# Access Compliance Report

## Public Rights-of-Way

### (Curb Ramps)

Intersection ID: 10018240	Main Street: BIRCHSTONE_LN	Cross Street: N/A	Location: E
ADA ID: 0C62B495DE82	Ramp Type: Perp	Initial Pass/Fail: Fail	Overall Compliance: No
		Severity Score: 8.75

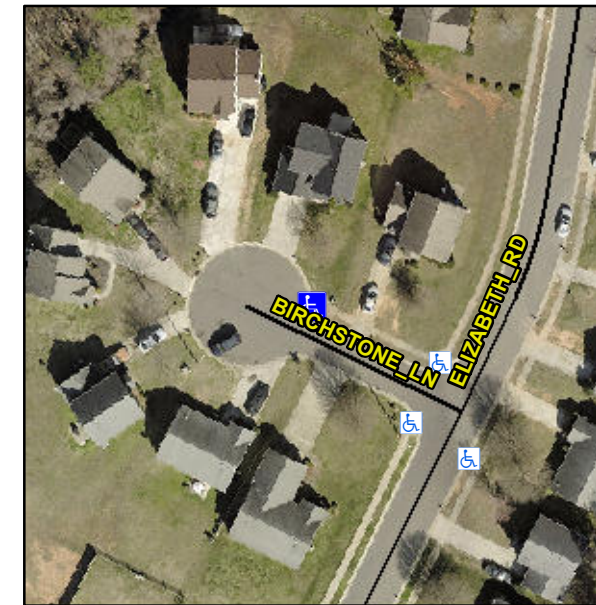
**Not Found, R304.5.1**

Compliance	Description	Data	Compliance	Description	Data
N/A	Ramp Length (in)	53.0	Yes	Ramp Slope (%)	7.4
No	Ramp Width (in)	36.0	Yes	Ramp XSlope (%)	0.8
N/A	Flare Type LT	N/A	N/A	Flare Type RT	N/A
N/A	Flare Slope LT (%)	N/A	N/A	Flare Slope RT (%)	N/A
N/A	Flare Traversable LT?	N/A	N/A	Flare Traversable RT?	N/A
N/A	Landing Length (in)	N/A	N/A	DWS Provided?	N/A
N/A	Landing Width (in)	N/A	N/A	DWS Contrast?	N/A
N/A	Landing Slope (%)	N/A	N/A	DWS Length (in)	N/A
N/A	Landing X Slope (%)	N/A	N/A	DWS Full Width?	N/A
N/A	Landing Curb? (Y/N)	N/A	N/A	DWS Offset (in)	N/A
N/A	Shared Landing?	N/A			
N/A	Gutter Ponding?	N/A	N/A	Gutter Slope (%)	N/A
N/A	Gutter Lip Ht (in)	0.5	N/A	Gutter X Slope (%)	N/A
N/A	Painted X Walk1?	No	N/A	Painted X Walk2?	N/A
	X Walk 1 Direction	To W		X Walk 2 Direction	N/A
N/A	X Walk 1 Width (in)	N/A	N/A	X Walk 2 Width (in)	N/A
	X Walk 1 Slope (%)	4.6		X Walk 2 Slope (%)	N/A
	X Walk 1 X Slope (%)	2.6		X Walk 2 X Slope (%)	N/A

**Remove & Replace Entire Ramp.**
